CITY OF ALBUQUERQUE

June 24, 2025

**RE: 2500 Phoenix Ave. NE
Conceptual Grading & Drainage Plan
Engineer's Stamp Date: 5/21/2025
Hydrology File: H16D156
Case # HYDR-2025-00060**

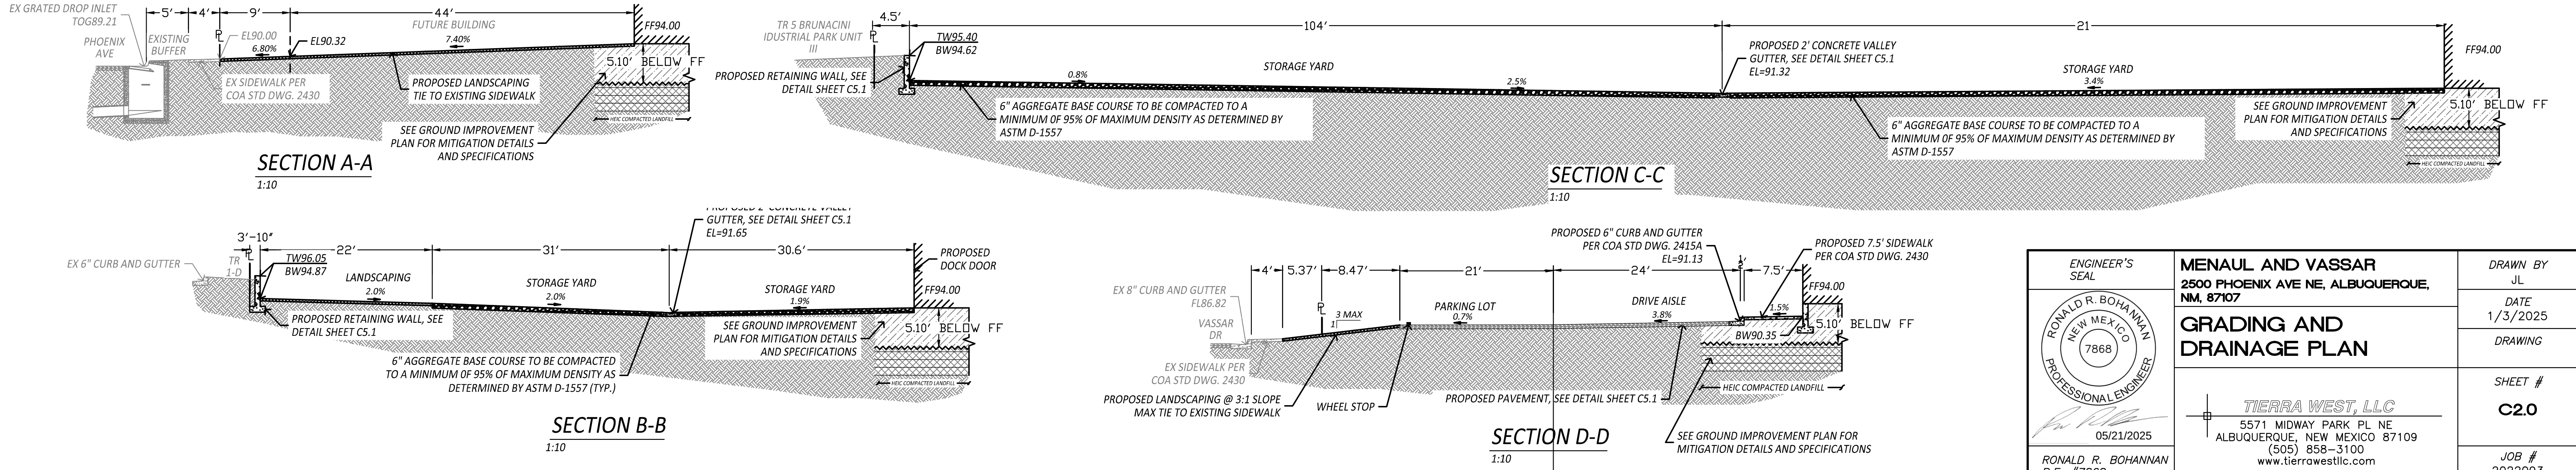
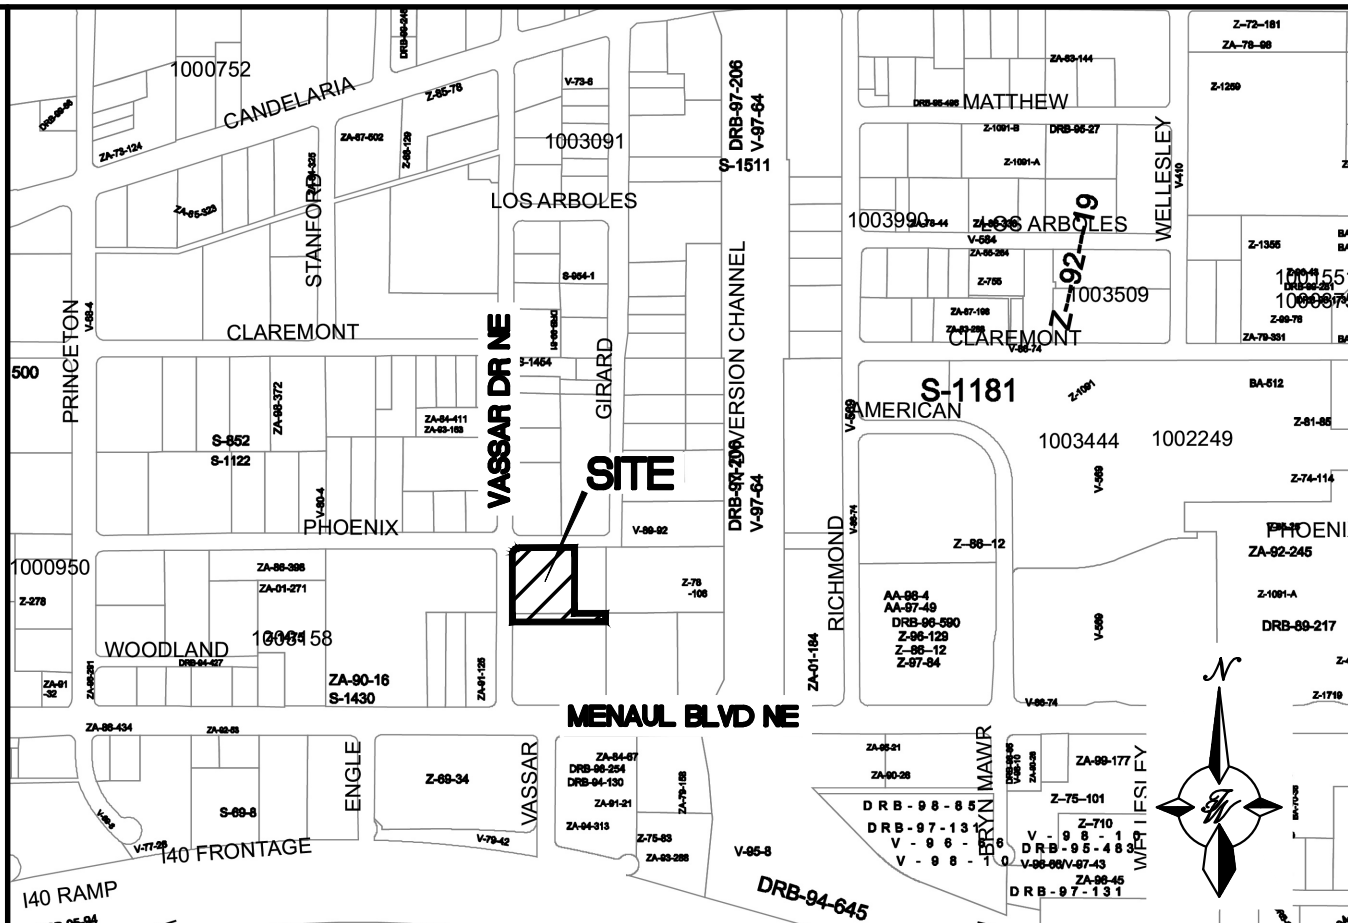
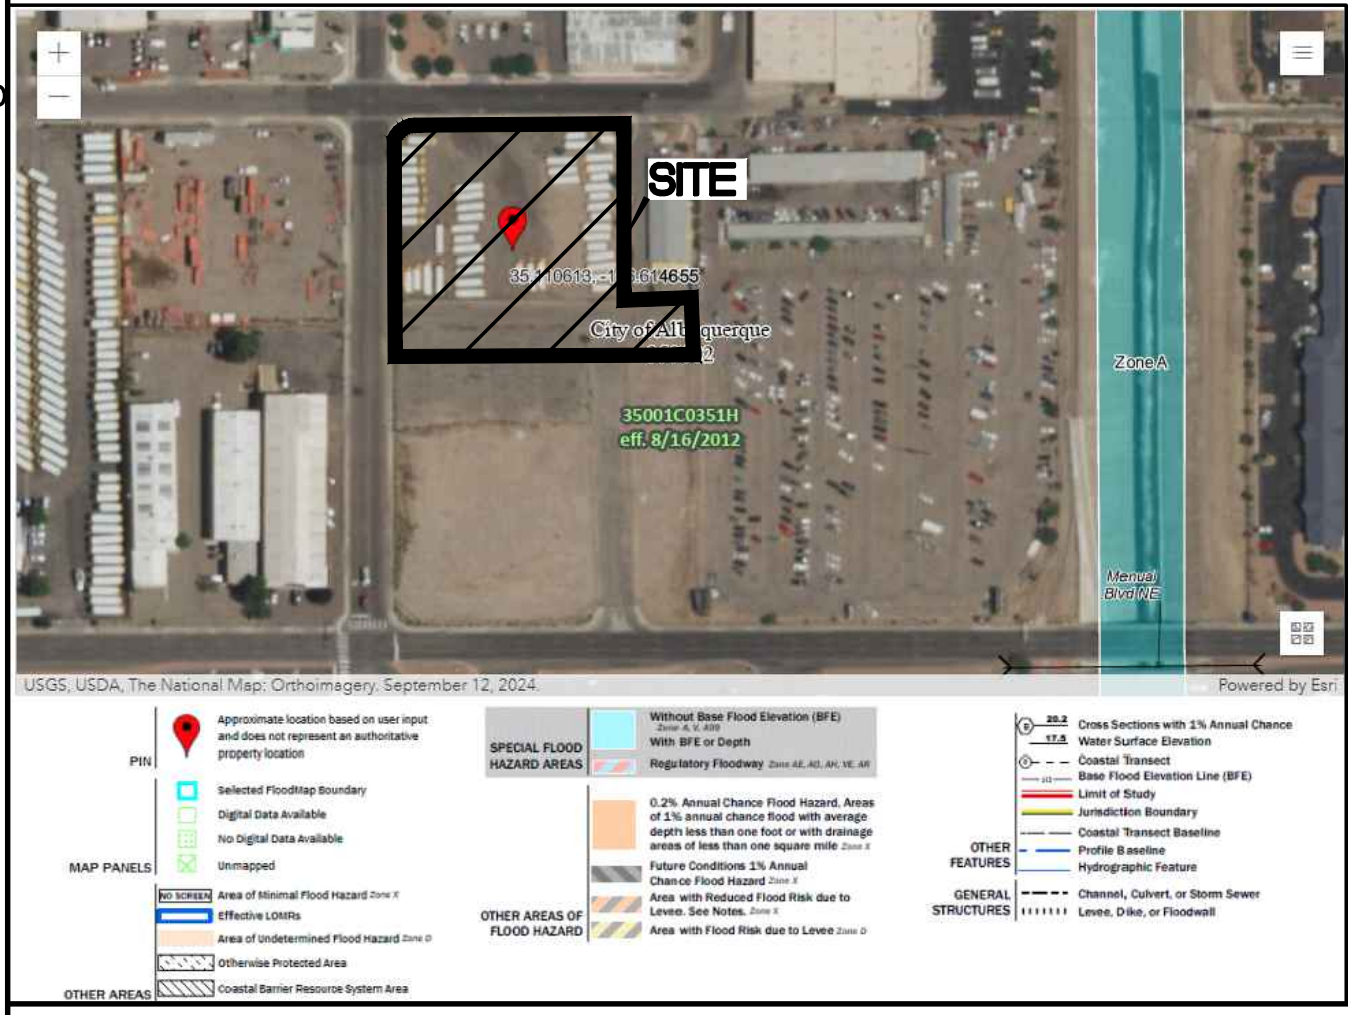
Based upon the information provided in your submittal received 05/21/2025, the Conceptual Grading & Drainage Plan is preliminary approved for action by the Development Facilitation Team (DFT) / Development Hearing Officer (DHO) on Site Plan for Building Permit and platting action.

1. Please submit a more detailed Grading & Drainage Plan to Hydrology for review and approval.
